21 October 2020

Our Ref: 20-0060swc3

Re: Art Gallery of NSW Expansion Project, Sydney Modern—Proposed Modification Landscape—Archaeological Assessment and Heritage Impact Statement

Figure 1 Art Gallery of NSW Expansion Sydney Modern Project, Landscape Master Plan (Drawing No. LD_DA_00-02). (Source: Art Gallery of New South Wales)

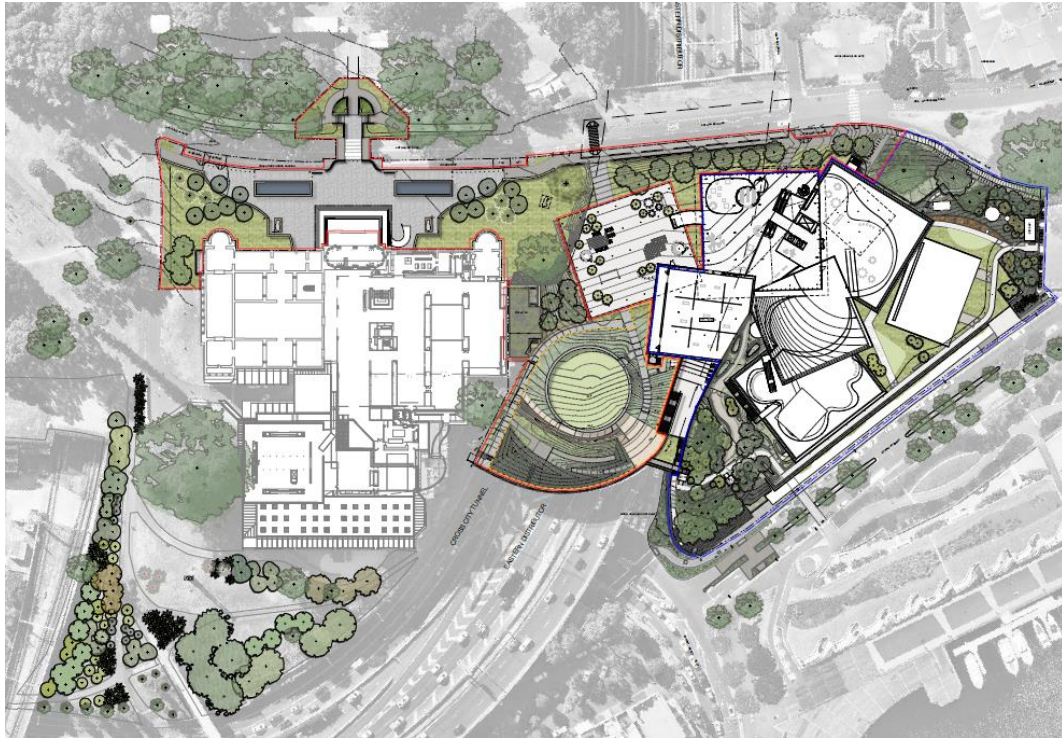
Generally, the Mod Landscape changes to the landscape design in the Vernon Curtilage will include areas of departure from the existing arrangement, which has remained largely unchanged and interpretable from the early twentieth century. The main components of the proposed modification that depart from the approved design include the raising and realignment of the dwarf sandstone retaining wall, introduction of new trees, introduction of new 'reflection pools' standing above ground levels to either side of the main portico, an alteration to the configuration of the footpath leading into The Domain and additions to the new land bridge garden.

The sandstone dwarf wall in front of the existing Gallery is identified as a significant element within the setting and landscape of the Art Gallery. Previously, this wall was used to demarcate the carriage loop leading to the entrance of the Vernon Wing. However, over the course of minor modifications to the forecourt the wall has been realigned in sections and has been accompanied by the building up of ground

levels over the years. The approved landscape design included demolition of elements of the sandstone wall to ground level. The proposed modifications to the landscape design now propose for the sandstone wall to be retained and relocated largely to its original alignment. This will require the sandstone wall to be removed in sections, raised and realigned as part of the overall modifications to the forecourt. The change in level for the sandstone wall will minimise the trip hazard of the wall, while also increasing the prominence of this element in the landscape. This proposed modification to the design would have a minor positive heritage impact, through the reinstatement of a significant element to a more prominent position and reset with reference to its previous, original alignment.

The existing Gallery building, and the landscape to its western elevation, is notable for its distinctive and formal geometry as well as the classical symmetry of the main elevation and its generally open character which allows full appreciation of the principal façade of the Vernon Wing. This open character is revealed on approach from the south by the heavily shaded and gently curved Art Gallery Road. The planting of 13 new red bloodwood trees (*Corymbia gummifera*) in front of the apsidal end bays of the principal façade of the Vernon Wing will significantly alter the historic—and current—open setting of the Vernon Wing. The number and density of the tree planting, their location and the height of the species at maturity (20–35m equivalent to between five and ten storeys) contribute to the visual intrusion. Significant views of the Gallery building on approach from both the north and south from Art Gallery Road would be altered by the proposed plan. The prominence of the original palm plantings would also be reduced by the new trees. The plantings of this species of tree in this location would be an adverse heritage impact on the building and its setting, and alternatives to this species and location should be considered with heritage advice.

The proposed modifications to the landscape design also include installation of new security features to the eastern side of Art Gallery Road, to the length of the existing Gallery forecourt. Depending on the scale, positioning and form of the bollards and retaining wall, proposed design modifications may lead to visual clutter in the existing open landscape around the Gallery. This may have a minor to moderate adverse heritage impact; however, this should be confirmed upon preparation of a detailed design for the proposed security measures and should be guided by heritage advice during development.

Refinement of the landscape design has also included the proposal to install two reflection pools to the west of the Vernon Wing. These pools, with a dual purpose of hostile vehicle mitigation and enhanced entry setting, would flank the axial approach to the entry steps to the central portico on the Gallery building. The rectangular pools would run on a north–south alignment, parallel to the Art Gallery building, and would sit above ground level. The pools would be a new addition to the historic setting of the gallery and details about the height required for hostile vehicle mitigation would need to be considered during detailed design development in order to avoid visual intrusion on the setting of the Vernon Wing. This should be guided by heritage advice during design development.

Currently, the southwest corner of the Vernon Wing has a concrete apron with earth at its edges retained by a wall. This apron wraps around the southern apsidal end bay from the western elevation to the southern elevation. The apron has not been identified as a significant element within the landscape of the Gallery. It is believed that this was installed during the mid to late twentieth century to mitigate moisture ingress and rising damp in this part of the building. Damp in the basement level at this corner is apparent. Mod Landscape proposes extending the turfed area up to the building with some form of separation proposed. Turf up to the building could exacerbate damp in the masonry of the building, however this could be mitigated with additional drainage and stormwater management. This should be guided by heritage advice during design development.

The approved landscape design currently includes a paved area between the existing building and the new landscaping to the southeast of the new gallery building, where the northern sculpture garden is currently located. Modifications to the landscape design seek to establish a plant-covered trellis—pergola—over a terrace on the north side of the Captain Cook Wing. The pergola would be freestanding and built to the height such that the bottom of the top frame would be set at the level of the bottom spandrel of the Captain Cook Wing’s northern elevation. The landscape in this part of the site is stepped down towards the east, with a sandstone outcrop, containing large mature plantings currently providing a screen to views between Art Gallery Road and the Captain Cook Wing northern walls. This sandstone outcrop would be retained and used to form the western border of the terrace, with the ground level of the terrace sitting below the sandstone, resulting in the terrace sitting low in the landscape, when viewed from Art Gallery Road. This proposed change to the landscape design will reactivate a hard, somewhat bare area of the landscape and improve the landscape setting to the north of the Gallery while also providing a softer integration point between the new and existing buildings. The significant views of the Art Gallery and from the Domain will be maintained, and no physical impacts would be required to the significant elements of the Art Gallery. The overall form and ‘massing’ of the pergola would not result in additional heritage impacts on the Art Gallery or the Domain. However, the materials, set out and detailing of this element would require heritage advice during detailed design development to ensure heritage impacts are mitigated.

The proposed design modifications to the forecourt of the Vernon Wing (the Vernon Curtilage) includes elements that retain and reveal the heritage significance of the place such as the serpentine dwarf wall’s reconstruction and the removal of the stark parking area. However, elements of the design of the forecourt—principally hostile vehicle management measures and the addition of potentially very tall groves of trees—would change the historic setting and may interrupt some key views to the existing gallery, thereby having potentially adverse impacts on the heritage values of the existing gallery.

The treatment of the landscape at the southwestern corner of the Vernon Wing has potential to cause direct impacts to the material conservation of the building which is showing damage by damp in this location. Detailed design should investigate and rectify moisture ingress at this location and elsewhere at the interface with the Vernon Wing so as to not only not exacerbate current defects but to remediate defects and put in place measures to care for the building in the long term.

2. The materials, set out and detailing of the pergola/trellis structure of the Trellis Garden should be reviewed and confirmed in detailed design development.

3. The details regarding the hostile vehicle management measures (including bollards and pools) and tree planting the forecourt of the Vernon Wing (the Vernon Curtilage) should be reviewed—particularly with regard to keeping views to the Wing from the north and south as open and uncluttered as possible.

4. The detailed design of the landscape at the southwestern corner of the Vernon Wing and along its western interface should include investigation and rectification of moisture ingress into the significant masonry fabric of the Wing and a strategy for the long term conservation of this fabric should be implemented as part of the works.

5. If trees are functionally essential in the forecourt, further investigation should be undertaken to select a species with a lower and more open habit. The location of individual trees should also be reviewed to minimise view impacts.

6. The proposed concrete retaining walls adjacent to Art Gallery Road should be reviewed in detail to confirm they are compatible with the significant elements and landscape setting of the Vernon Wing.
